RE: Cold Brook Crossing Project

As directed, I have reviewed the Stormwater Management Report for Cold Brook Crossing Project, prepared by Civil Design Group, LLC, dated March 11, 2020. The following are my findings and comments and preliminary recommendations.

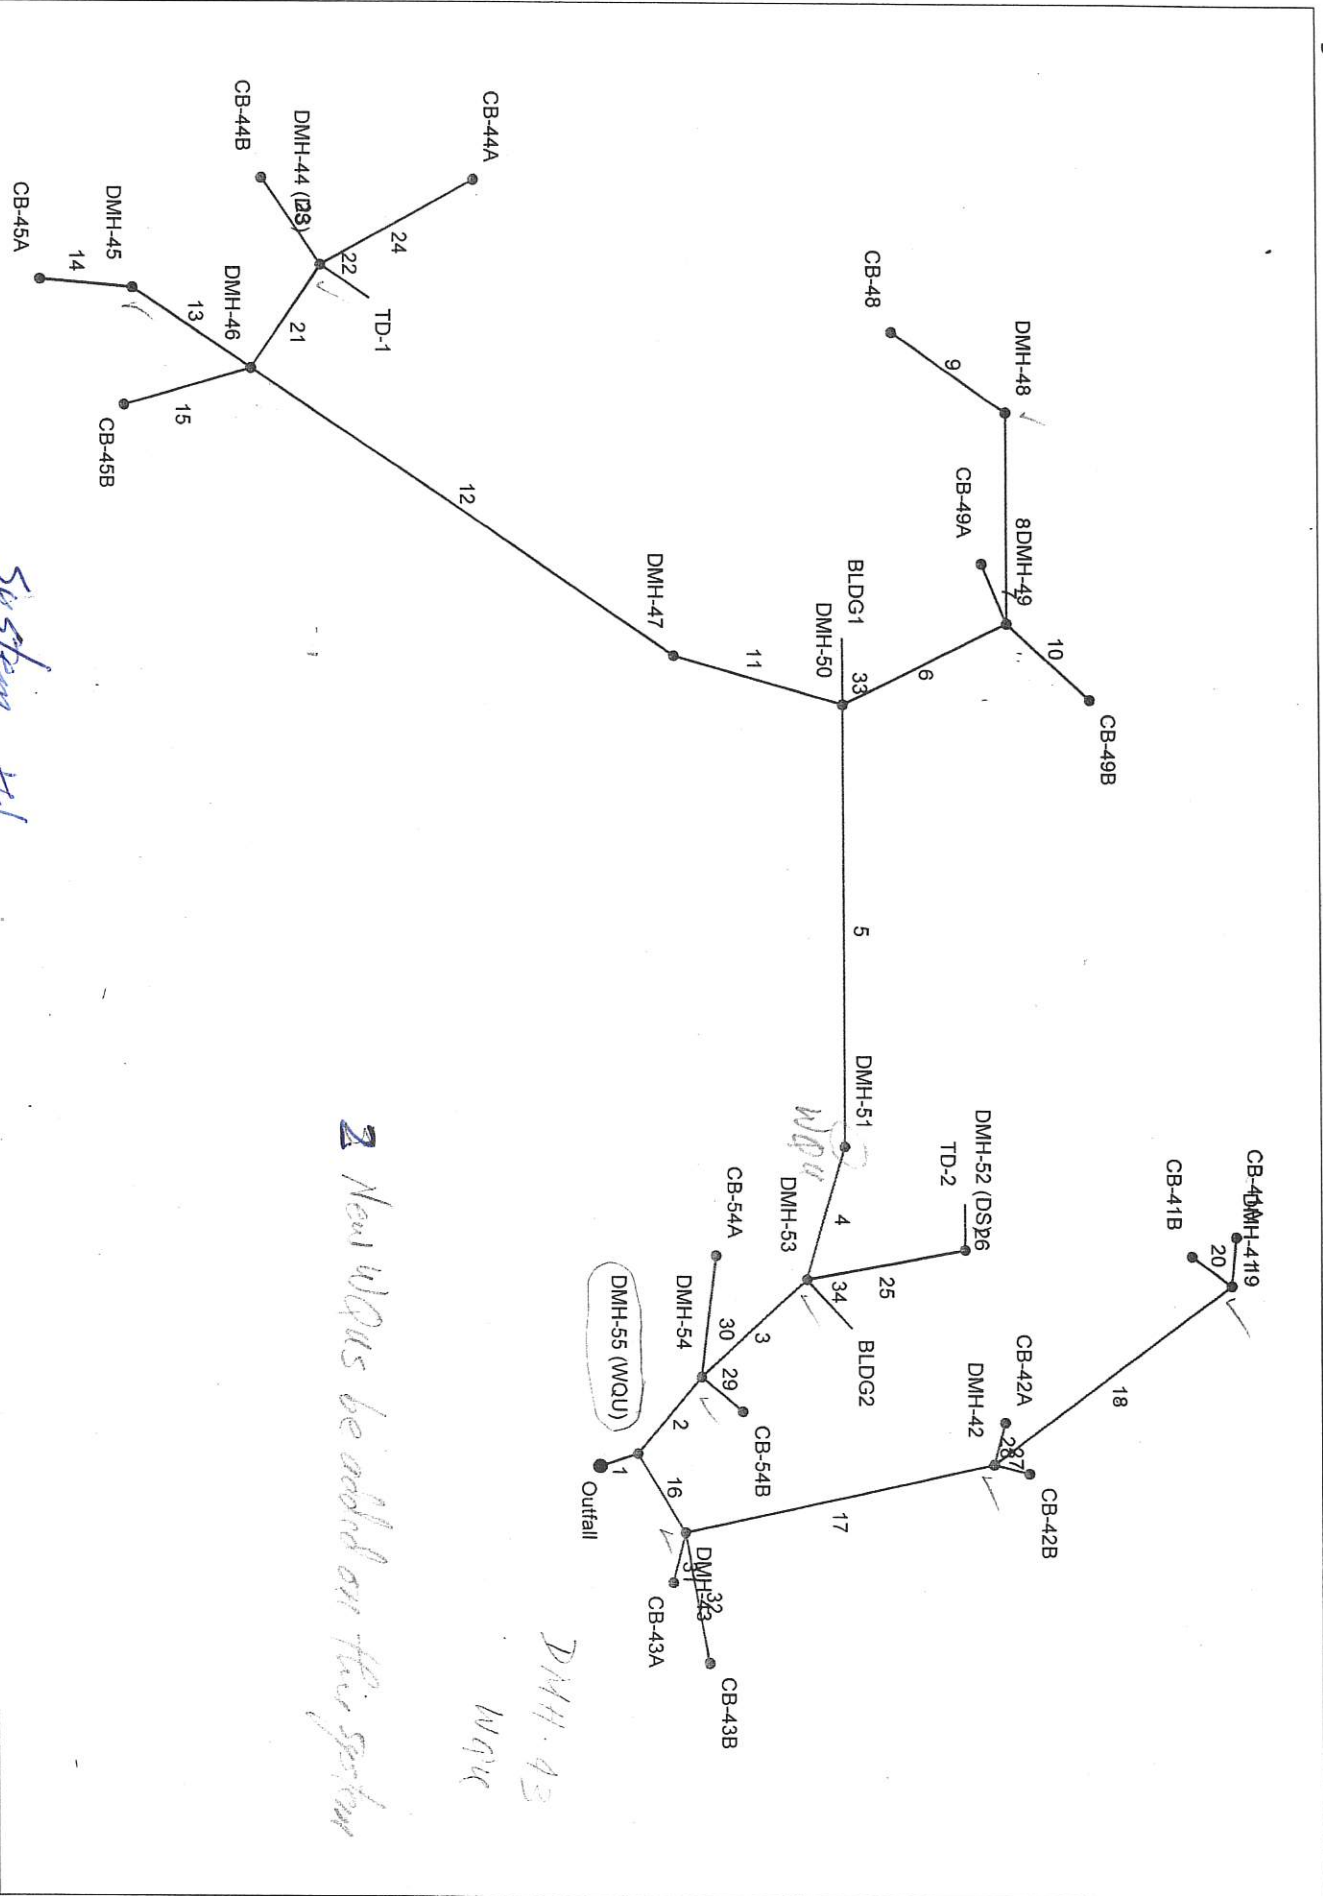
It is recommended that assume WQU does meet the treatment for water quality purpose, more WQU should be installed in the system. The reason is to avoid turbulence flow passing the WQUs.

1. Each WQU should sized based on inflow and make sure the passing through velocity is in the range of design standard.
2. On system #1 (Refer the plan) add two WQUs, one at DMH-51 the other at DMH-43.
3. On System #2 also add two WQUs, one at DMH-7 the other at DMH-13
4. System #3 is fine with the proposed one WQU.
5. System #4 is confusing. The plan and the computer calculation sheet are not mach. Based on computer sheets, flow from DMH-40 goes to SIS-7 and CB-SIS-7A also goes to SIS-7. That means the outfall is SIS-7.
6. System #5 need to add one WQU at DMH-33.

Project File: System-1Basin.stm

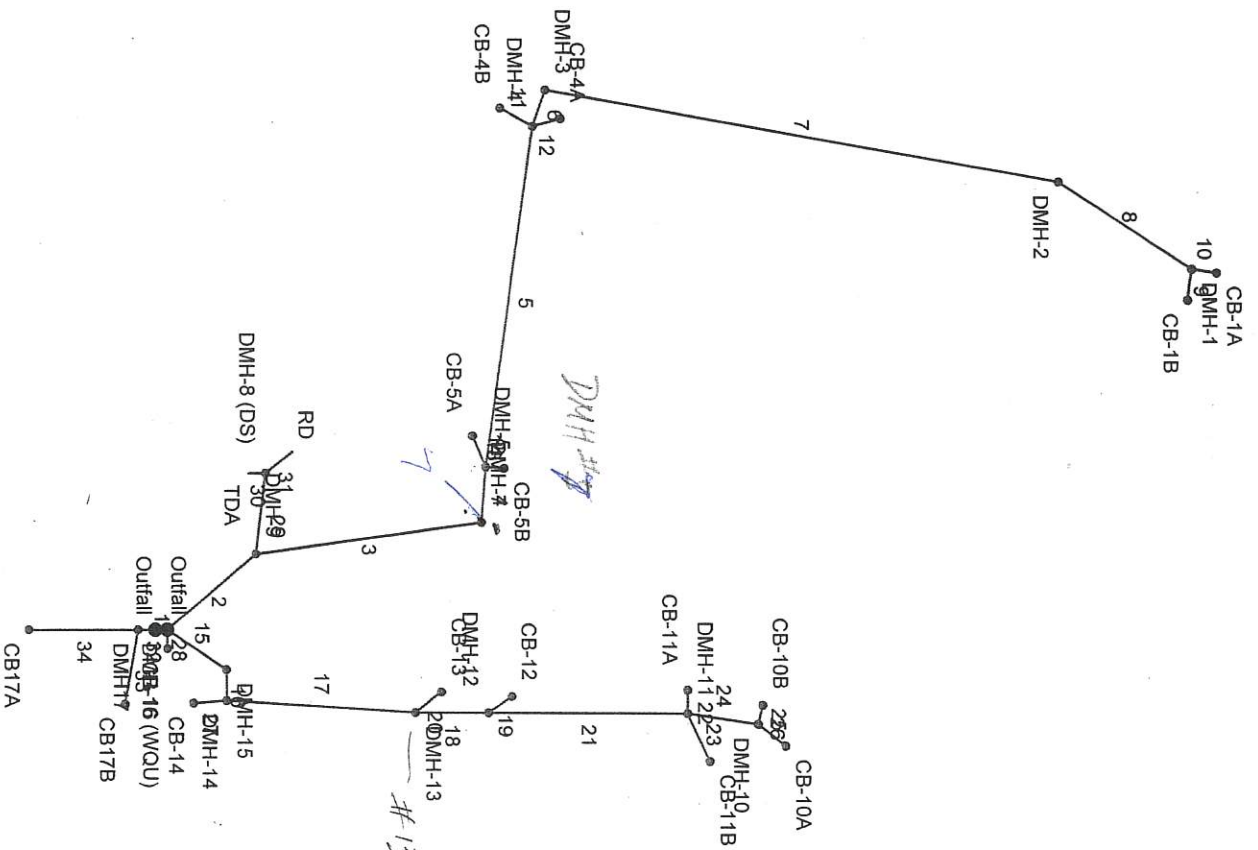
3. The capacity of WQU should be determined for each proposed WQU. Too large of water quantity passing through a WQU, it may not be able to control the water quality for it design for. For example: On system #1, refer to plan, only one WQU was proposed. It shall be located at DMH-55. The peak flow passing through is 23.89 cfs. With 24 inch diameter pipe, the flow velocity, assume pipe flow full, is 7.6 ft per sec. This velocity is much higher than erosion velocity. Flow at this velocity goes into a DMH. It will become turbulence and WQU can not function as it should.

4. The results from the Auto CAD computer program analysis have some problem. I can accept that the total flow quantity reduction when two pipe joint together at a DMH, its outflow is less than the sum of two inflows, which may due to the time of concentration varies thus the two peak flow are not occur at the time, but I can not accept the flow rate reduction when flow passing through a DMH with no outlet. It is against the principle of hydraulics. This only can happy if the piping system has leak. For example: System #1, Line 5 has flow rate of 11.71 cfs but the down stream Line 4 only has flow of 11.49 cfs, a

1.88% flow reduction. Same as Line 12 to Line 11, flow reduced from 7.54 cfs to 7.27 cfs, 3.58% flow reduction. There are so many un-reasonable flow reductions. Flow reduction may not impact the water quality issue, but it may cause problem for sizing the leaching facility or detention/retention basin and cause overflow problem.
